March 8, 2024

SUBJECT: Bicycle Plan Update | Transportation Committee resolution re: Maryland Avenue, Johnson Pkwy to Ruth St

Figure 3. February 2024 planned network does not include a separated bikeway on Maryland

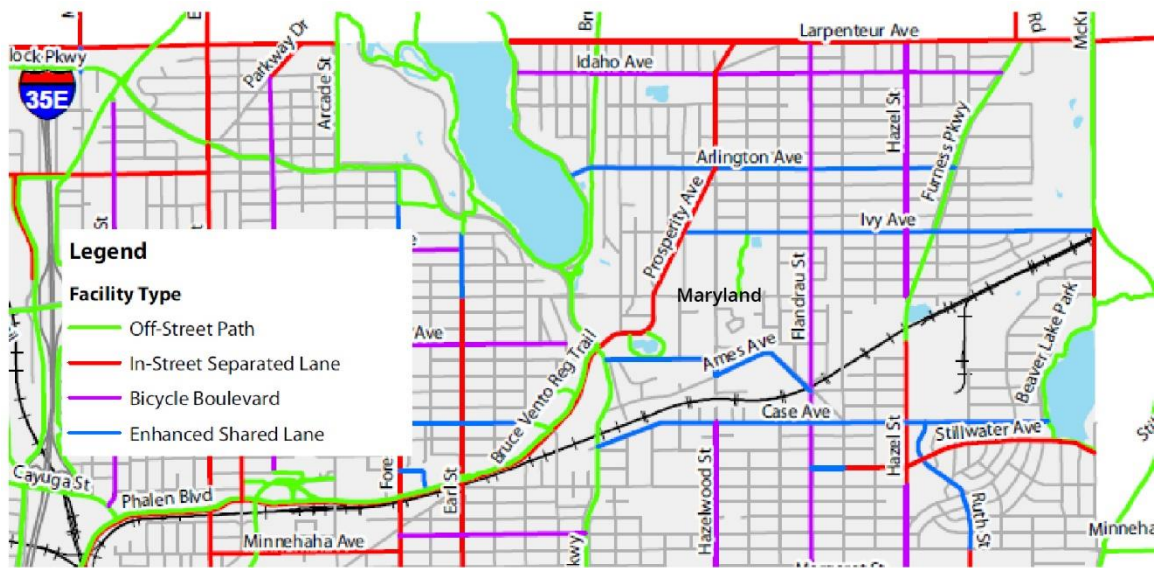
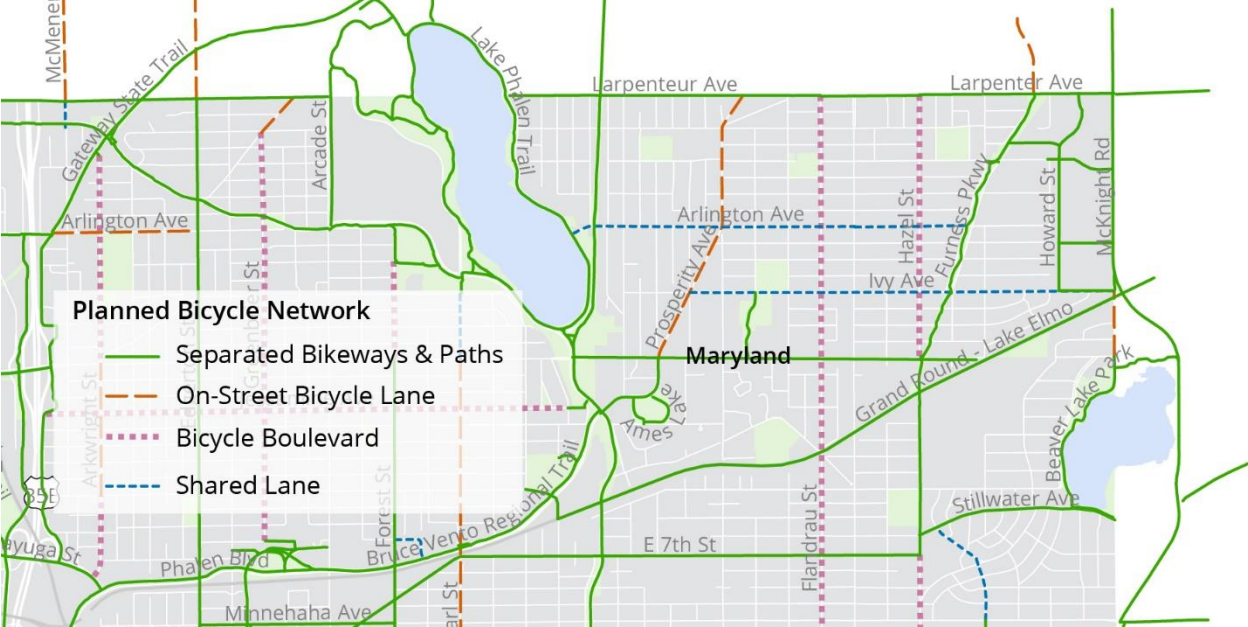
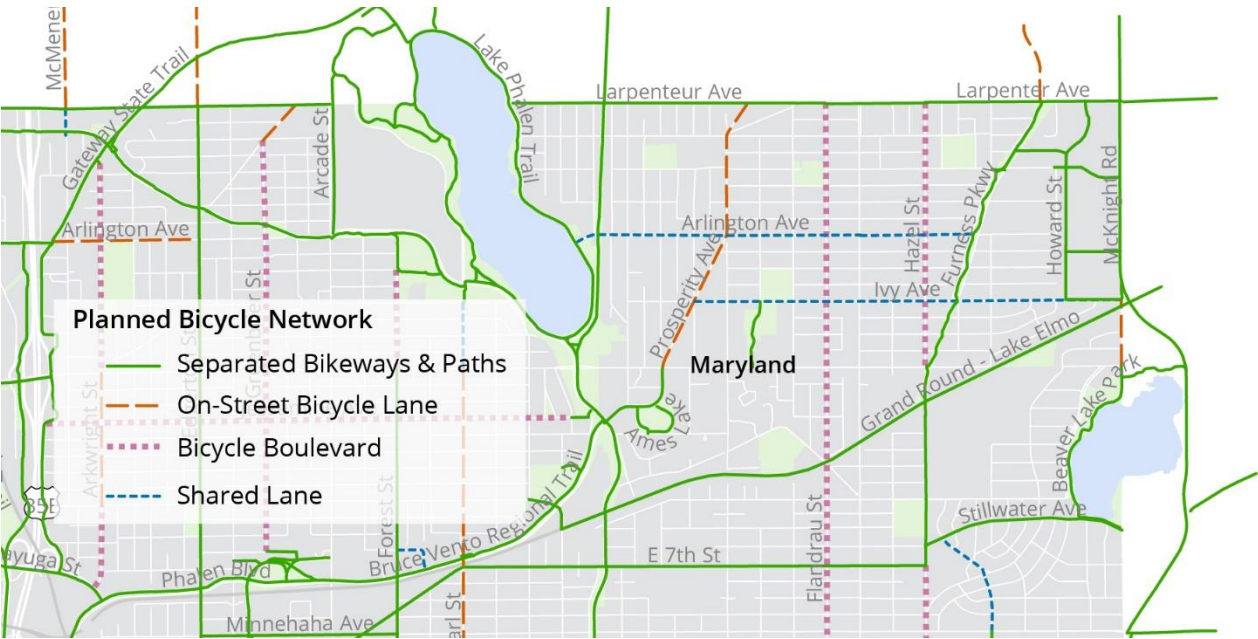
As recently as the December 2023 draft of the updated Bicycle Plan, a section of Maryland Avenue between Johnson Parkway and Ruth Street was identified for a planned separated bikeway (Figure 2). Based on feedback from the Public Hearing on February 2, and after discussions with Ramsey County and the Purple Line BRT design team, staff recommended prioritizing the limited space on Maryland for future transit. As a result, the February 2024 revision to the draft planned bicycle network *did not* recommend adding a separated bikeway on this segment of Maryland (Figure 3). Ultimately, the February 2024 planned bicycle network represents no change in recommendations from the current Bicycle Plan (adopted 2015).

Public Works staff have reviewed the updated resolution recommended by the Transportation Committee on February 26. After consideration, staff commits to the recommendation that the portion of Maryland Ave between Johnson Pkwy and Ruth St NOT include a planned bikeway of any kind. Right-of-way space along this portion of Maryland is highly constrained, and a high quality bikeway (one that meets best practices and includes separation) would be difficult to accommodate with other uses being considered on the corridor.

Planned Bicycle Network

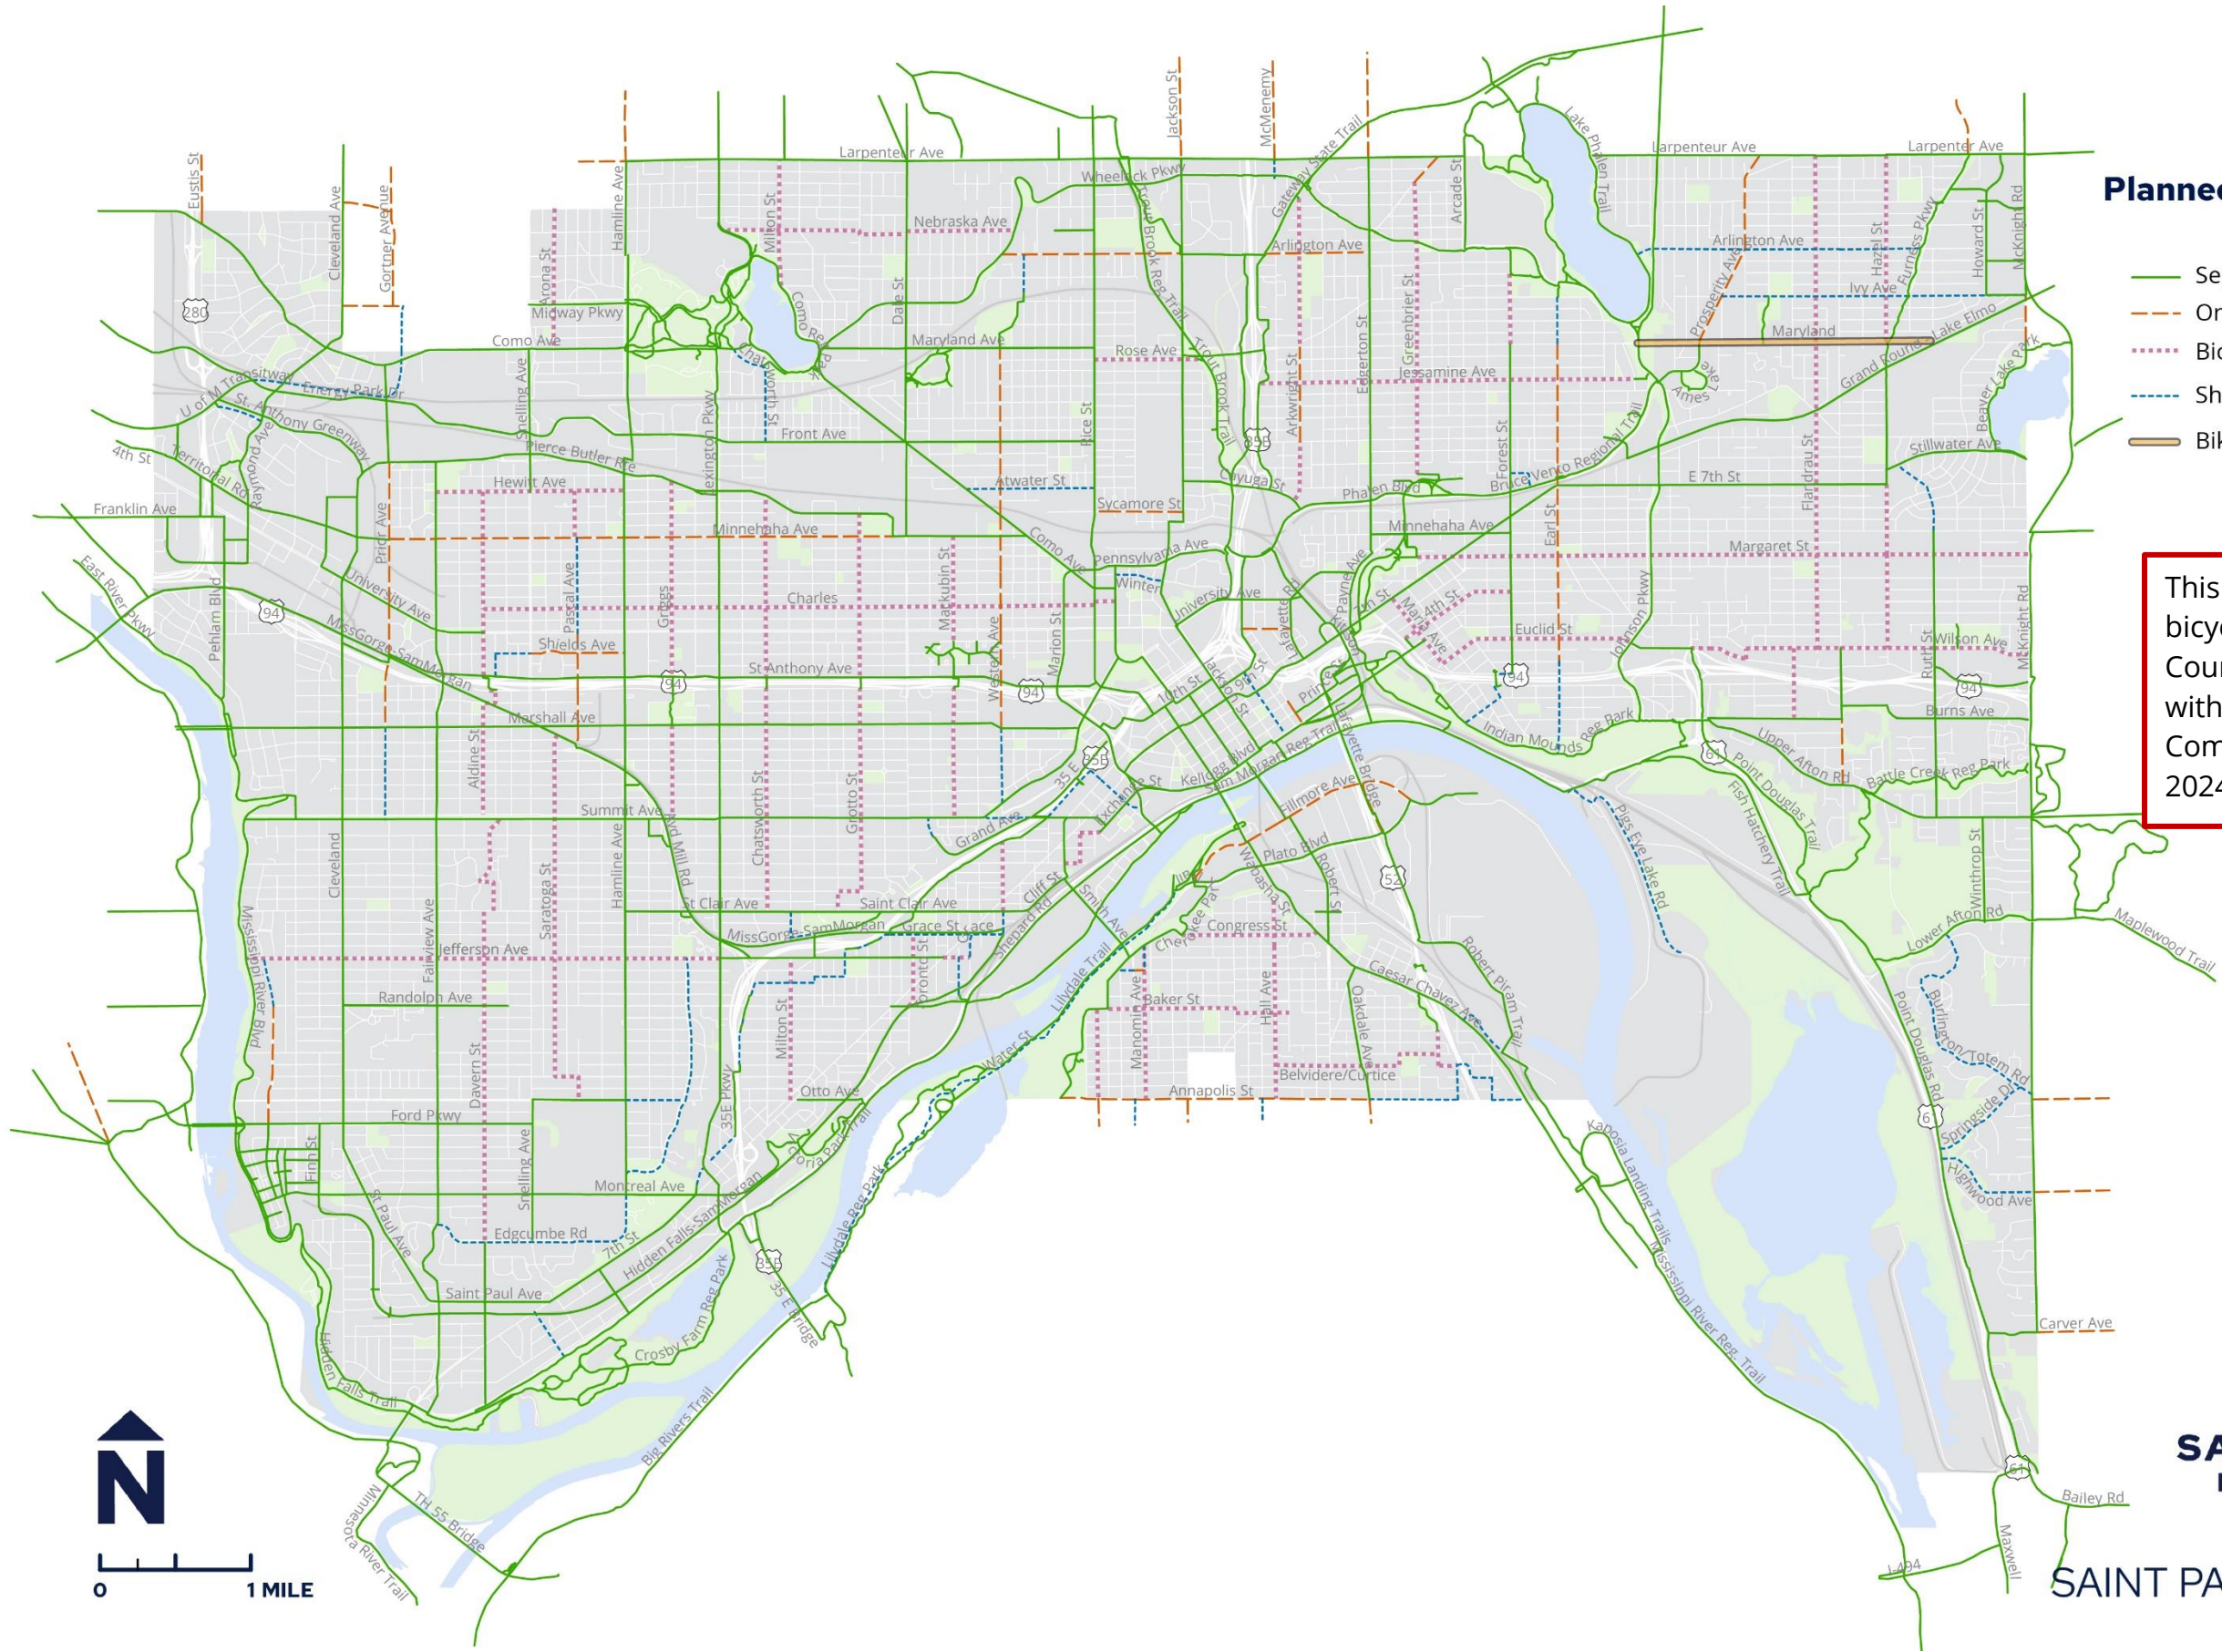
- 1. A new line be added to the Planned Bicycle Network map on Maryland Avenue east of Johnson Parkway to Ruth Street, in a manner that recognizes and prioritizes transit planning processes in that segment; and**

- On the Planned Bicycle Network map, a line on Maryland would be added between Johnson Pkwy and Ruth St. The corresponding line in the map legend would read "bikeway for further study". This would be the only such line on the planned network map. There are several additional maps in the Plan that show the planned bicycle network. This same section of Maryland would be included in all the maps featuring the planned network. Please see the map attached at the end of this document.
- In the Plan document, this section of Maryland would be acknowledged as unique and called out specifically. Language would be added on page 52 of the Plan dated February 23, 2024 that reads:

Maryland Avenue between Johnson Parkway and Ruth Street is shown in the planned bicycle network as "bikeway for further study". Currently, a portion of this section of Maryland between Johnson and White Bear Avenue is being considered for future high frequency transit service by the Purple Line Bus Rapid Transit (BRT) and H Line Arterial BRT. At the time of adoption of this Bicycle Plan, it is not known what the future of design will look like for this portion of Maryland, if and how space for people biking can be accommodated, and the timing of implementation of any future designs. Future coordination is needed between the City, Metro Transit, and Ramsey County, the agency who owns and designs Maryland between Johnson and White Bear Avenue.
